MEMORANDUM

Subject: North 40 Advisory Committee Meeting Report

Date: June 21, 2013

GROSVENOR

MEASURING POINT

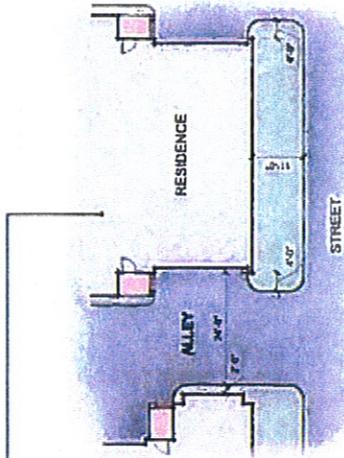
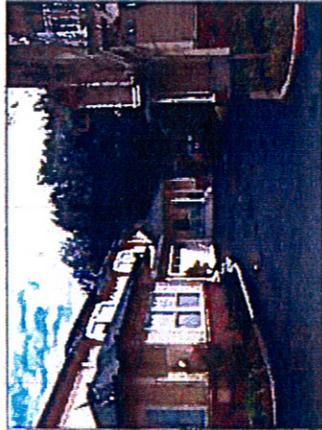
There are three reasons that suggest the measurement from finished grade (not the lower of the two) is the best approach for the North 40:

- The North 40 is an extensive area that will undergo neighborhood-wide grading; the former grading, an orchard, is not meaningful in the creation of an integrated new neighborhood, nor for the purpose of building height measurement.

- The 'waterfall' grades coming off LG Boulevard create an awkward condition that should be remediated, plan- wide. Measuring from a sudden dip that's no longer going to exist is illogical. The waterfall is a result of the difference between a 20th century engineered thoroughfare and an earlier remnant of agriculture, now surrounded by asphalt on all four sides. The site must now conform better to adjacent roads and be better integrated. Why penalize for trying to integrate?

- Rational plans call for a largely flat site; adding a hill is not planned. If plans called for grades to be significantly raised, and building height measurements were taken from finished grade, the builder might benefit by using the new grade as the measuring datum. Planned, rational grading calls for a) best practices storm water management and b) easing the waterfall condition to integrate the development with the Town; not for berming to gain height advantage.

PROPOSED STREET SETBACKS

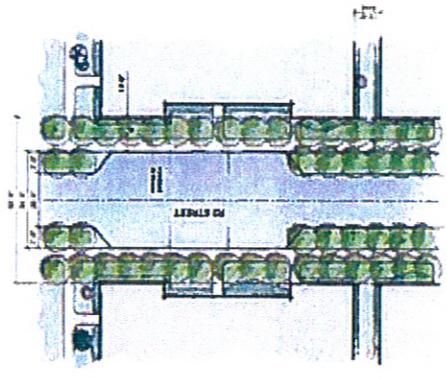
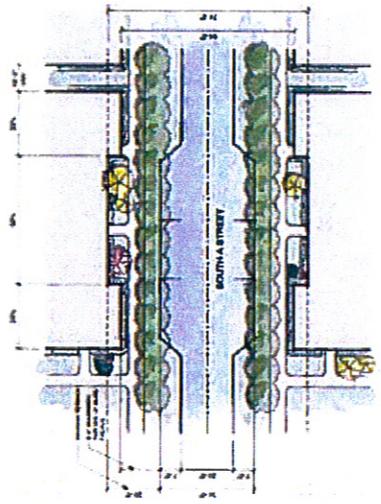
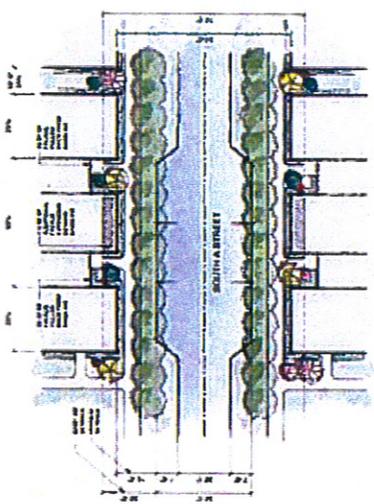
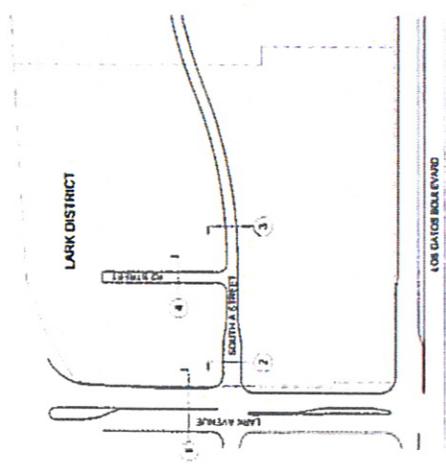
Before you began your review of the Draft Specific Plan, we identified four primary areas that we wanted to discuss. They were: building setback requirements; residential product design; commercial signage; and street sections. These were in addition to our concern about height which was shared last August. At the May 23rd and June 5th meetings, the Committee had comprehensive conversation about building setbacks, product design, street sections and height, and we anticipate commercial signage will be discussed at an upcoming meeting. While it seemed there was general consensus and direction provided to staff and the Specific Plan consultants to consider alternate standards and parameters, it was not clear to us what changes would be made in the final draft. Please consider our comments when instructing staff to make the final edits. Exhibit B includes expanded discussion about height as well as methodology for measurement. Exhibit C (provided to you last meeting) shows how providing flexibility in setbacks would result in a more interesting and higher quality neighborhood design.

- 2-18: South A Street Lark District: Set back should be 18' not 24'
- 2-19:
 - Neighborhood Street: Curb acts as wheel stop (too much detail?)
 - Neighborhood Street: revise Setback Design description to state "Set back design shall include 15' area to be hardscaped with a minimum of 8' clearance at building edge, landscaped planters'... remove the 5'0" dimension noted on the sidewalk section."
